BAR Meeting
June 16, 2010

ISSUE: Permit to Demolish/Encapsulate, Addition/Alterations and Waiver of Rooftop HVAC Screening Requirement

LOCATION: 923 South Royal Street

BAR CASE #2010-0123 & 0124 6/16/2010

Figure 13. Sight lines for proposed rooftop HVAC units.

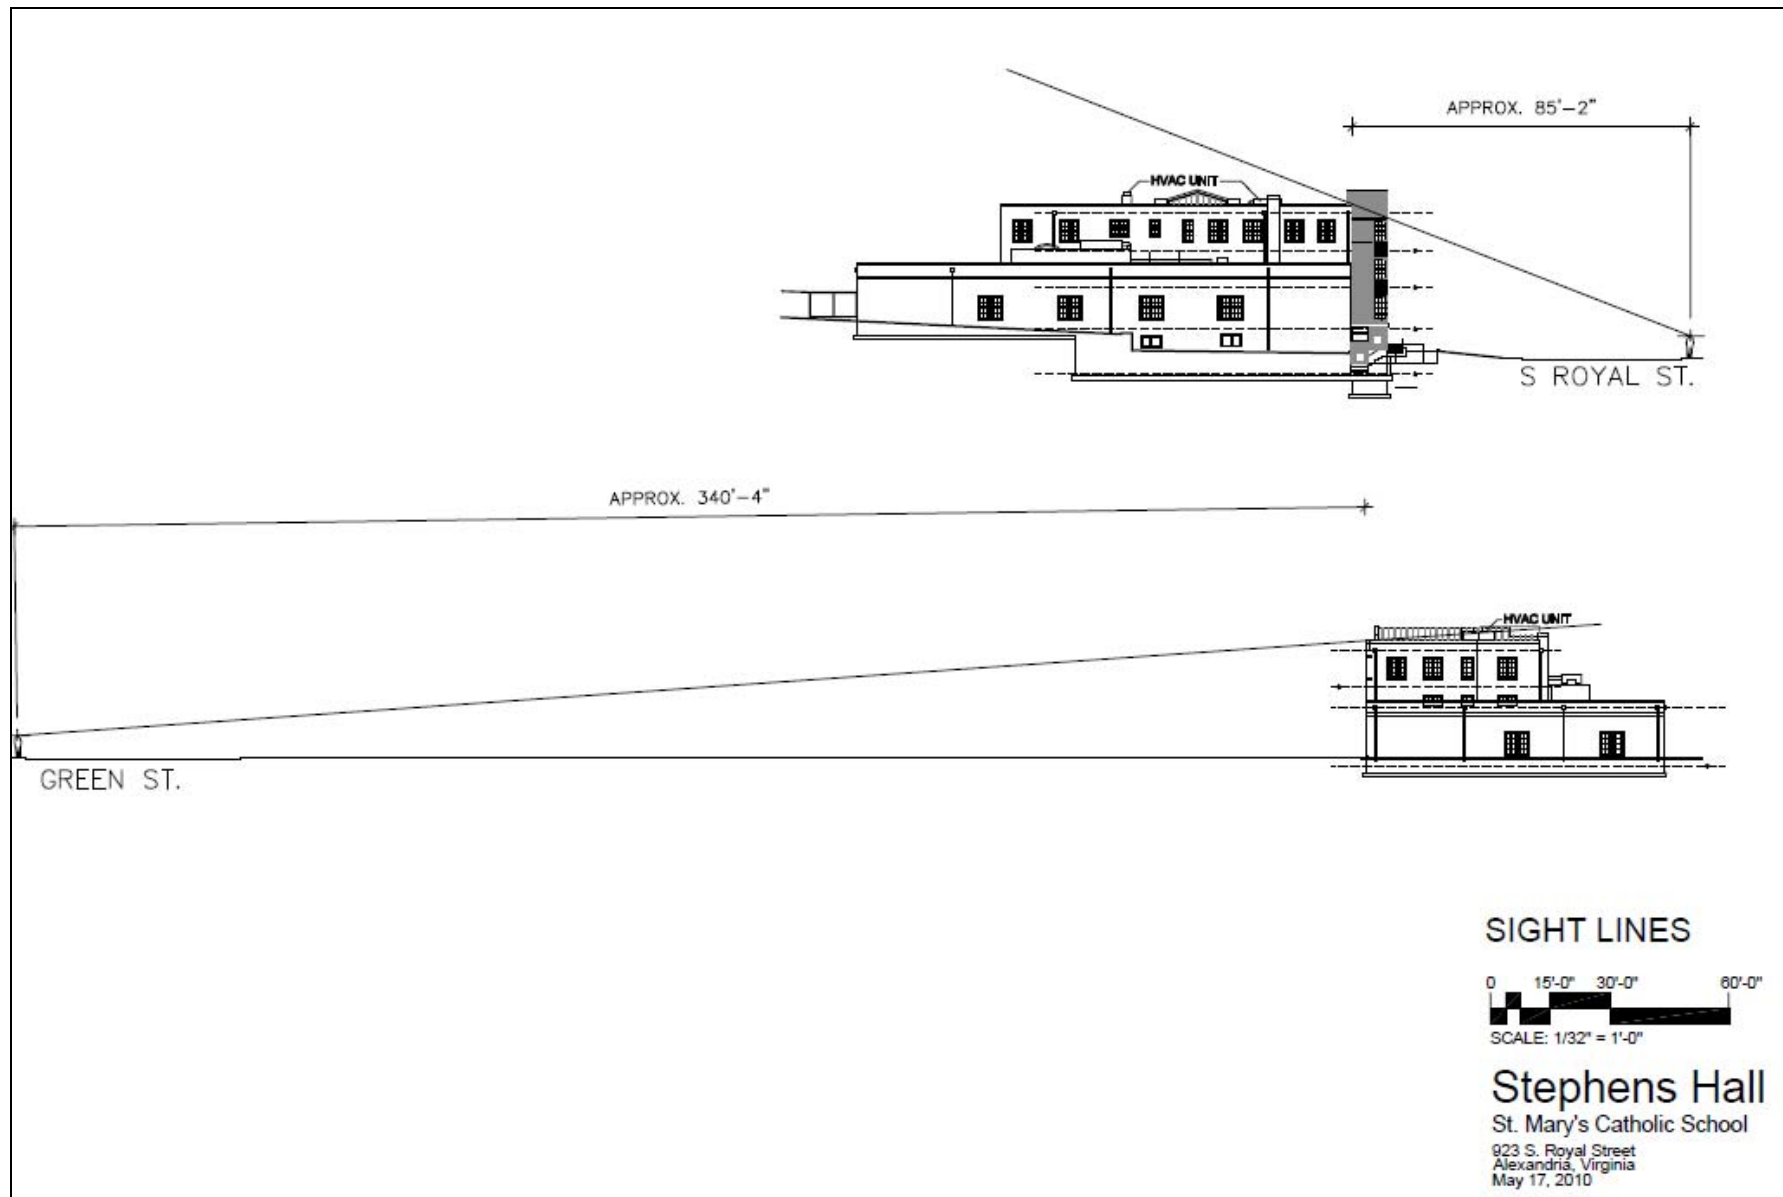
Staff has no objection to the waiver of the rooftop HVAC screening requirement and notes that the sight lines submitted by the applicant indicate that the proposed units will be minimally, if at all, visible from the public right-of-way. Further, in many instances rooftop screening often draws more attention to the HVAC units and the screening itself.

Figure 14. Proposed windows.

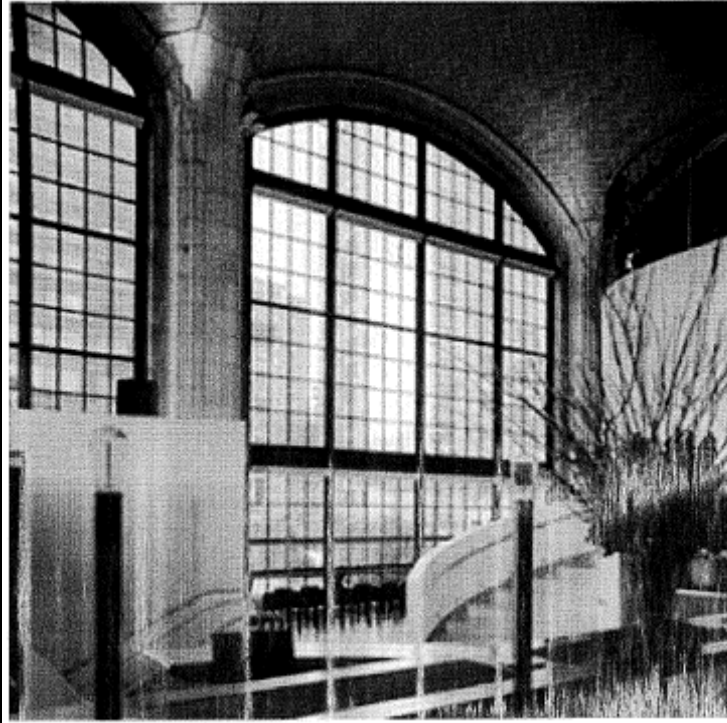
Staff believes the proposed window materials are appropriate for a mid-20th century building addition. While the *Design Guidelines* state that “single glazed true divided light wood windows” are the preferred window type, Staff notes that the Board has regularly approved simulated divided light, double-glazed windows on buildings from the 1950s. The use of steel-framed windows is also appropriate for an institutional building from this period. The architect has matched the proportions of the existing double hung window panes but has wrapped them around the corner to subtly distinguish this addition from the original building. Corner windows were common architectural detail in the early and mid 20th century and this feature appears on numerous masonry buildings constructed during this period throughout the historic district.
